# Reliability Analysis Update

Transmission Expansion Advisory Committee

April 7, 2026

# Scope / Cost Changes

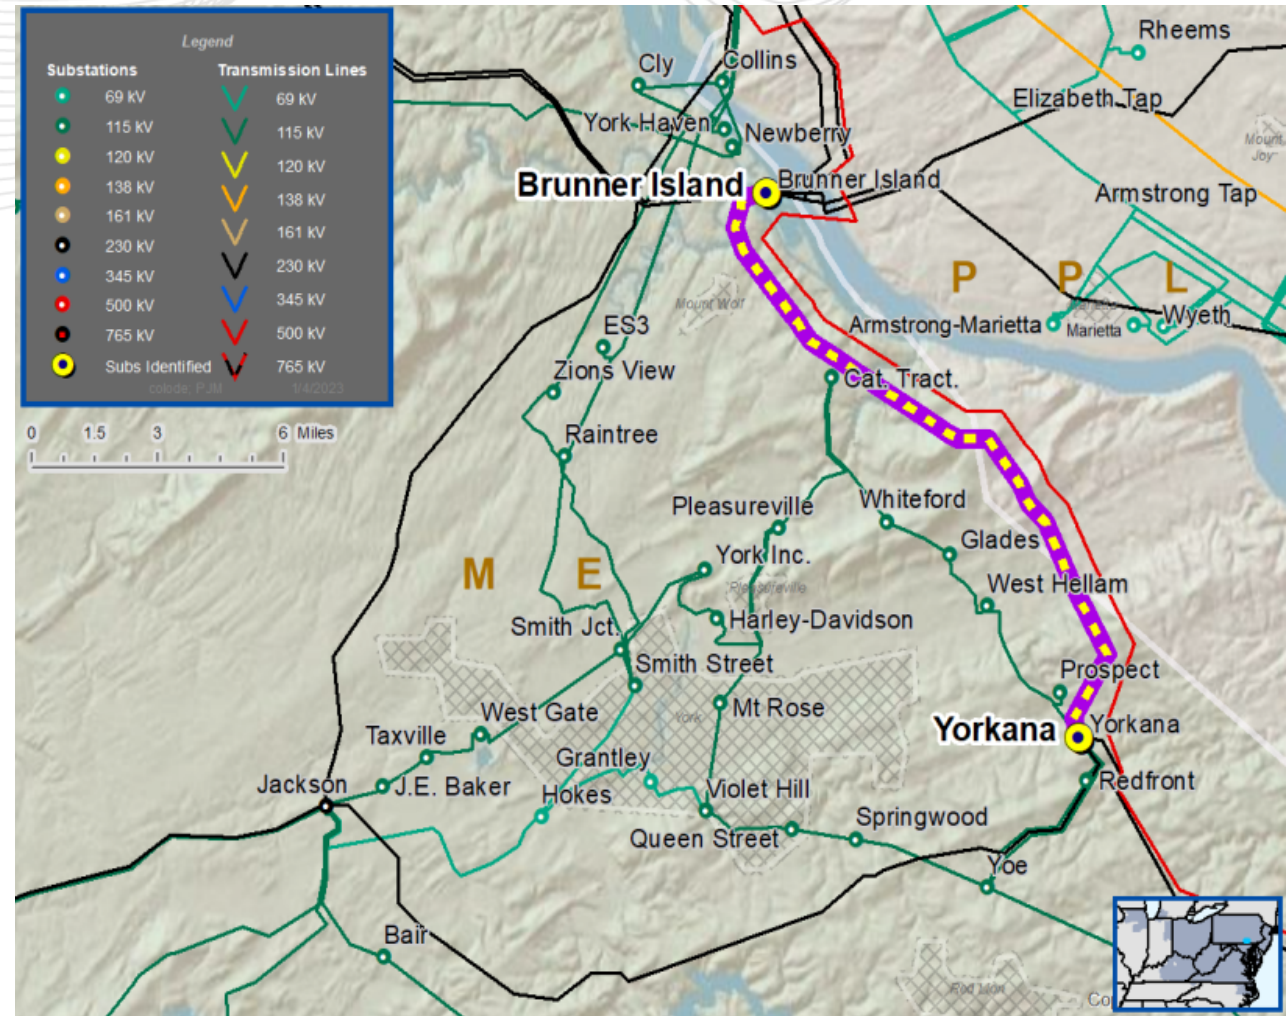
The Brunner Island – Yorkanna 230 kV circuit is overloaded for single contingency.

Reconductor/rebuild 0.64 miles of the PPL side of the Brunner Island - Yorkanna 230 kV circuit. (b3774)

Replace structure 1055-1 with new steel pole dead-end structure at the MAIT/PPL demarcation point on Brunner Island – Yorkanna 230kV line. (b3774.2)

**Estimated Cost:** ~~\$2.5 M~~ **\$4.3M** (Increase of 1.8 from b3774.2)

## Scope change for B4000.355 – B4000.359 (New Yeat – Joshua Falls 765kV line, Yeat 765/500/230kV Substation)

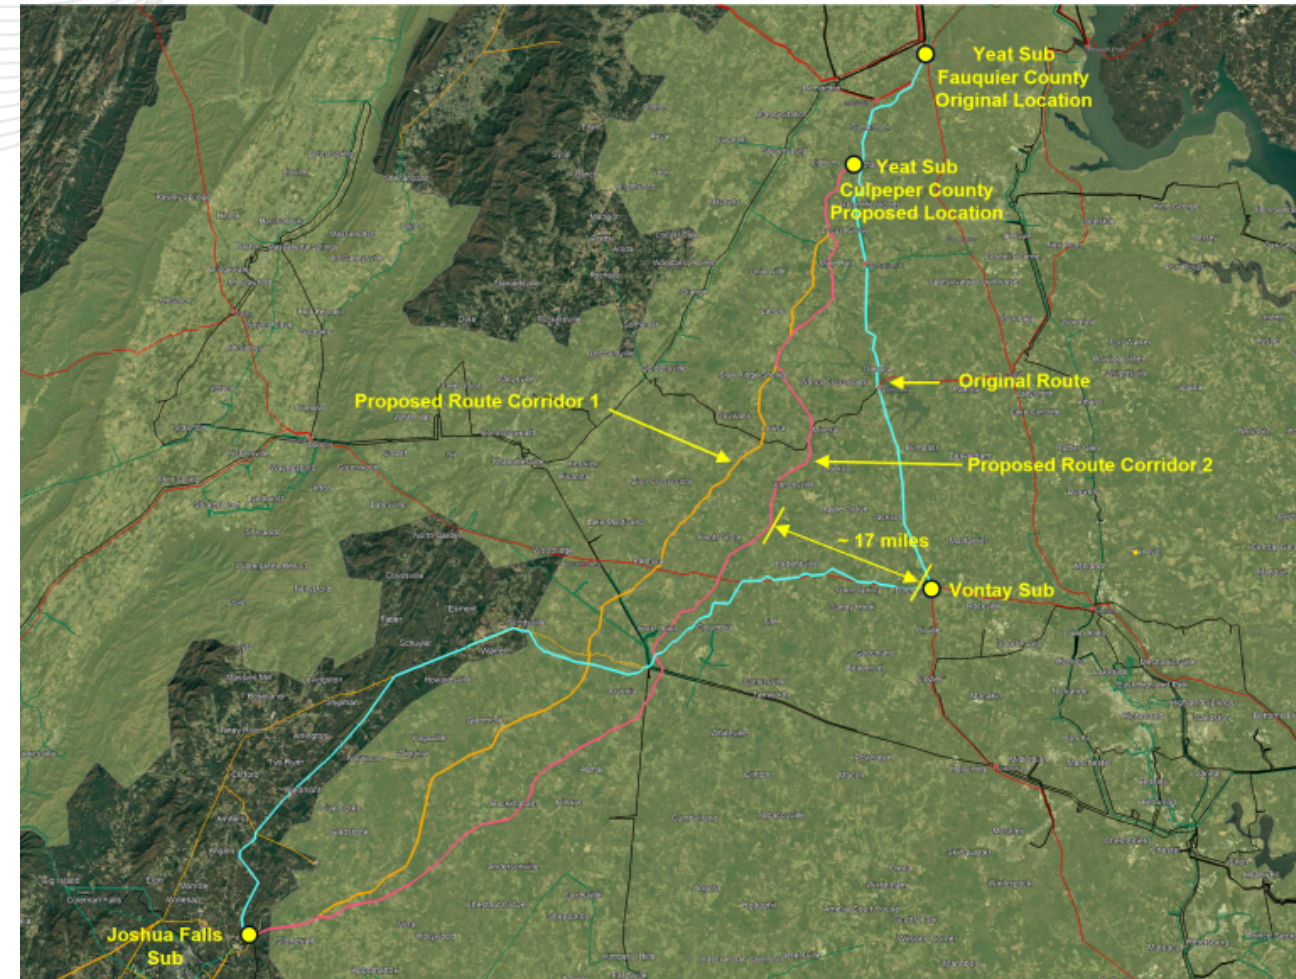
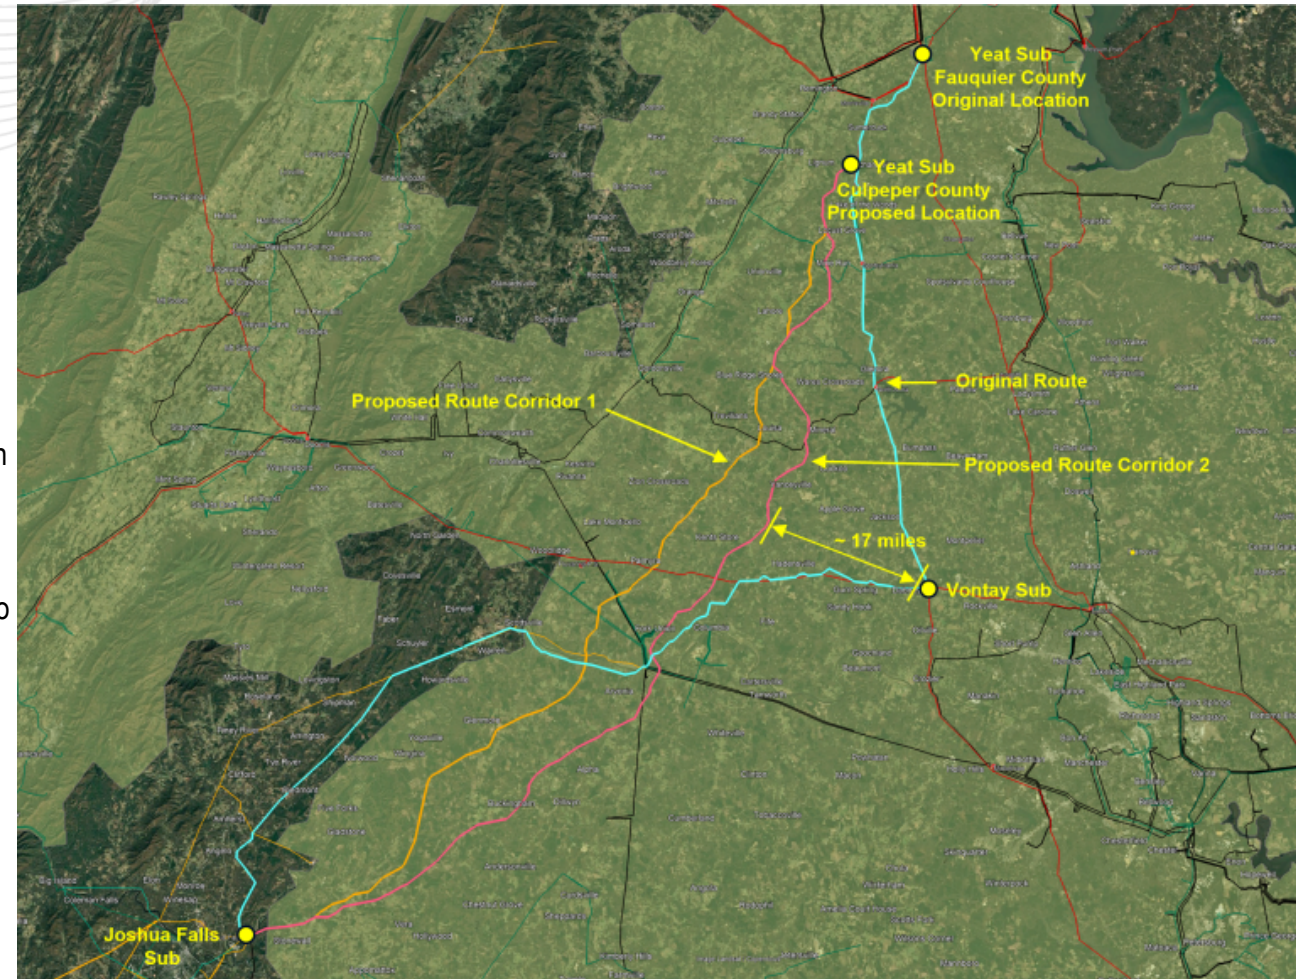
- Enhancement to schedule certainty to meet project's in-service date
- Reduce potential residential, environmental, cultural and historical impacts
- Consider options to reduce new greenfield 765kV line mileage and associated cost/value benefits
- Offers comparable Transfer limits to the originally approved/selected proposal from 2025-W1
- Requires minor adjustments to earlier approved developments in the area (as will be explained in following slides)

Part of the recommended solution for 2024 Window 1 (2024-W1-820) is to construct a new 765/500/230kV substation called Yeat & construct a new 765kV line from Joshua Falls to Yeat.

- Build a new 156 mile 765kV line from Joshua Falls – Yeat. (Roughly 69.3 miles in AEP section). **(b4000.355) \$341.17M**
- Build a new 156 mile 765kV line from Joshua Falls – Yeat. (Roughly 86.7 miles in Dominion section). **(b4000.356) \$426.83M**
- Build a new 765/500/230kV substation called Yeat. Install (2) 765/500 kV transformers. Cut in 500kV line Bristers – Ox and 500kV line Meadowbrook – Vint Hill into Yeat. **(b4000.357) \$197.1M**
- At Yeat substation, install (1) 500/230kV transformer. Cut in 230kV line Vint Hill – Elk Run into Yeat substation **(b4000.358) \$45.6M**
- Add (2) 765kV breakers at Joshua Falls substation. Substation expansion is required to add the additional breakers. **(b4000.359) \$99.19M**

**Preliminary Transmission Arrangement for Yeat substation relocation in Culpeper County & supporting reinforcements**

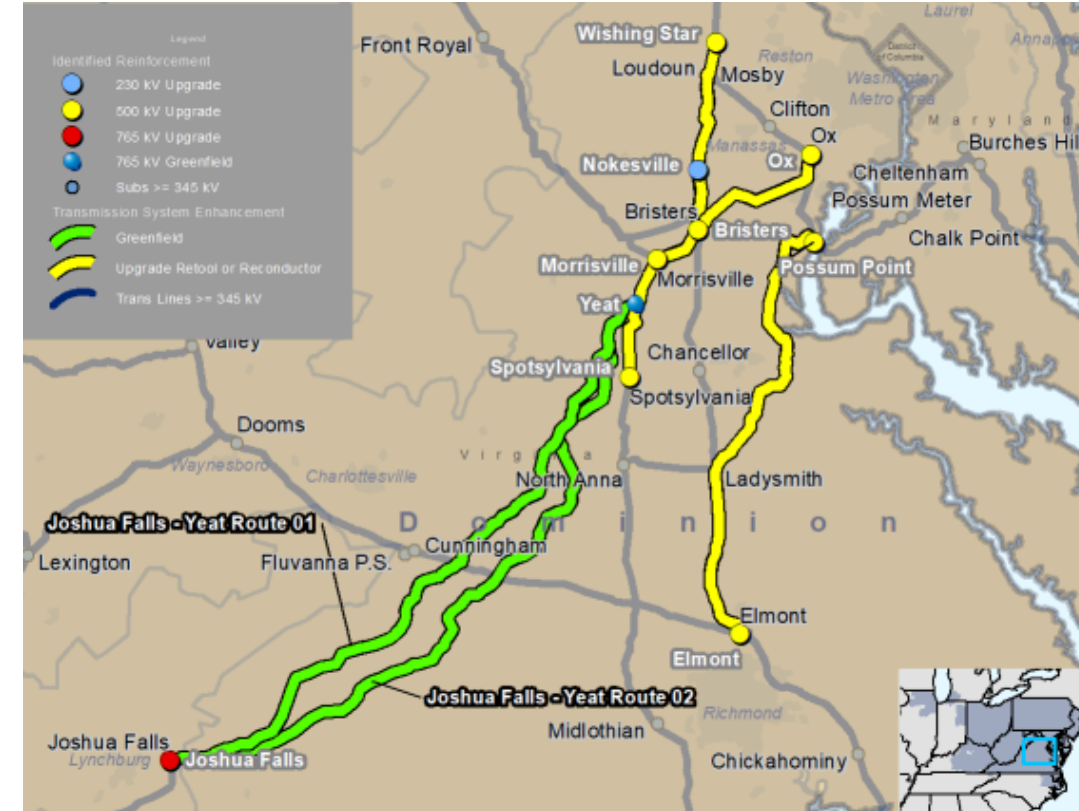
- Relocate Yeat 765kV substation further south by ~15 mi
- Reduce (shorten) Joshua Falls – Yeat 765kV greenfield line to 115 miles
  - 765kV line will head directly towards Yeat (N-E direction from Joshua as shown in map and will no longer pass by Vontay)
- Remove 230kV yard at Yeat
- Cut-in Culpeper Yeat into 500kV Line #594 Spotsylvania - Morrisville
- Extend Morrisville - Wishing Star 500kV line by 7.5 mi from Morrisville to Culpeper-Yeat (using existing ROW)
- Move Kraken loop 500 kV line termination to Bristers (Previously Yeat), reducing length by 1.5 mi

- Rebuild ~8 miles of existing 500kV Line #594 from Yeat to Morrisville
- Tie the Morrisville – Bristers and Bristers – Nokesville 230kV lines by removing line terminations at Bristers (bypassing the Bristers substation)
- Upgrade Bristers 230/115kV transformer
- Revise the Yeat – Ox 500kV line (~21 mi) rebuild scope from 2025W1 (b4053.23) to rebuild Bristers – Ox 500kV line (~23 mi) (~2 mi extra)
- Tie the Elmont – Kraken and Kraken – Possum Pt 500kV lines by removing line terminations at Kraken (bypassing the Kraken substation)
- Rebuild 500kV Line #594 Spotsylvania to Yeat 500kV line (~11 mi)

- Build a new 500kV line from ~~Morrisville Culpeper Yeat~~ to Vint Hill. New conductor to have a summer rating of 4357 MVA. Line length is approximately ~~49.74~~ 27.21 miles. (b3800.356) ~~\$101.89M~~ \$150.64M
- ~~Upgrade and install equipment at Morrisville substation to support the new 500kV conductor termination.~~ Terminal equipment at Morrisville substation to be rated for 5000 A for 500kV Line #545 & #569. Upgrade 500 kV bus 2 to 5000 A. (b3800.346) ~~\$17.54~~ \$12.54

- Build a 500kV line from a new substation called Kraken to ~~a new substation called Yeat~~ Bristers. New conductor to have a minimum summer normal rating of 4357MVA. (b4000.345) ~~\$394.71M~~ \$384.96M

- Cut-in 500 kV line from Kraken substation into ~~Yeat~~ Bristers substation (b4000.346) \$5M (No cost change)
- Build a new ~~156~~ 115 mile 765kV line from Joshua Falls – ~~Culpeper~~ Yeat. (Roughly ~~69.3~~ 5 miles in AEP section). (b4000.355) ~~\$341.17M~~ \$24.62M

- Build a new ~~156~~ 115 mile 765kV line from Joshua Falls – ~~Culpeper~~ Yeat. (Roughly ~~86.7~~ 110 miles in Dominion section). (b4000.356) ~~\$426.83M~~ \$541.54M

- Build a new ~~765/500/230kV~~ 765/500kV substation called ~~Culpeper~~ Yeat. Install (2) 765/500 kV transformers. Cut in 500kV line ~~Bristers—Ox and 500kV line Meadowbrook—Vint Hill Spotsylvania – Morrisville~~ into Yeat. (b4000.357) ~~\$197.10M~~ \$187.10M

# Dominion Transmission Zone: Baseline Second Chickahominy 500/230kV Transformer

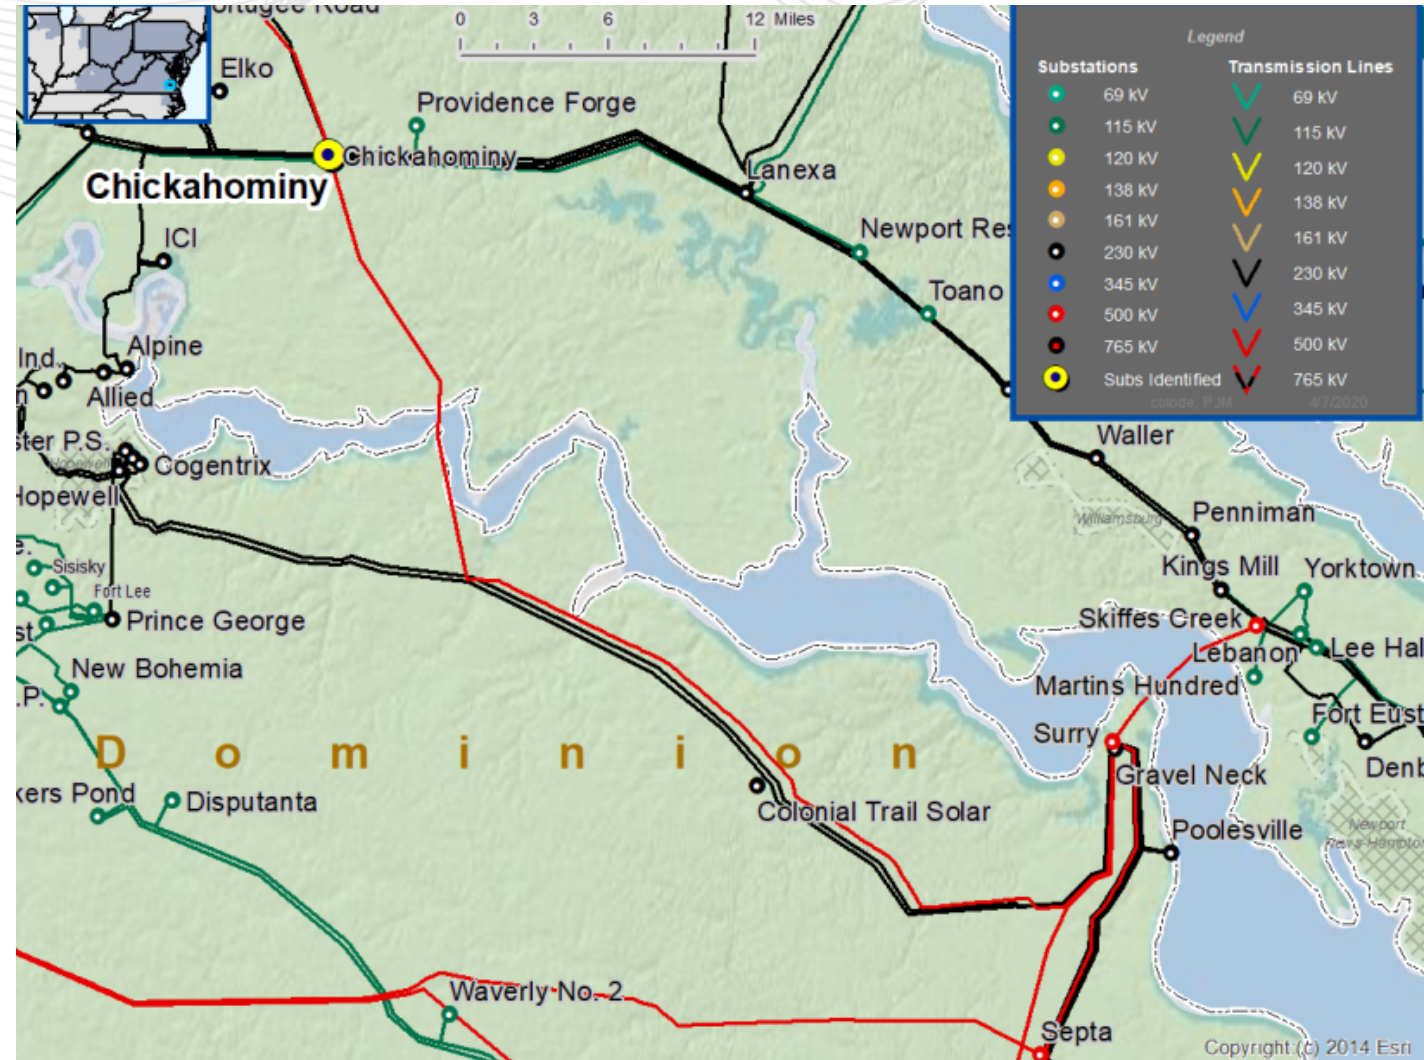
- Chickahominy 500/230 kV transformer is overloaded for loss of Chickahominy – Surry 500 kV line

- ~~Install a 2nd Chickahominy 500/230 kV transformer~~
- Reconfigure 500kV portion of substation into a ring bus
- Relocate the Chickahominy – Elmont 500kV line #557 to terminate in a new bay at Chickahominy substation and relocate the Chesterfield – Lanexa 115kV line #92 to allow for the expansion of the Chickahominy substation
- Add three new 500 kV breakers with 50kA interrupting rating and associated equipment

- 2024 RTEP W1 & 2025 RTEP W1 analysis indicates that the 2<sup>nd</sup> transformer is not required at this time.

Estimated Project Cost: ~~\$31.05M~~ \$34.03M
